# **SERVICE BULLETIN Supplement**

## **SB-42-019-2015 FUEL PUMP C42-Series**

### **Subject:**

- The previous determination that the electric fuel pump should be switched on even after the start can be canceled if the modification described below is carried out on the fuel system.

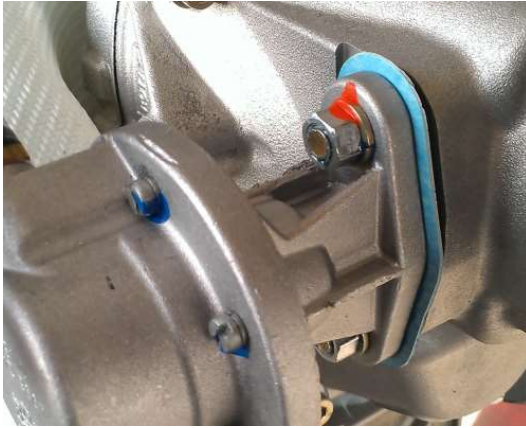
- 2) The Comco additional gasket is placed on the pump side in addition to the sealing package. (Art-Nr .: ZK-0539)

The Comco add-on gasket is significantly larger and blue in color for better visibility.
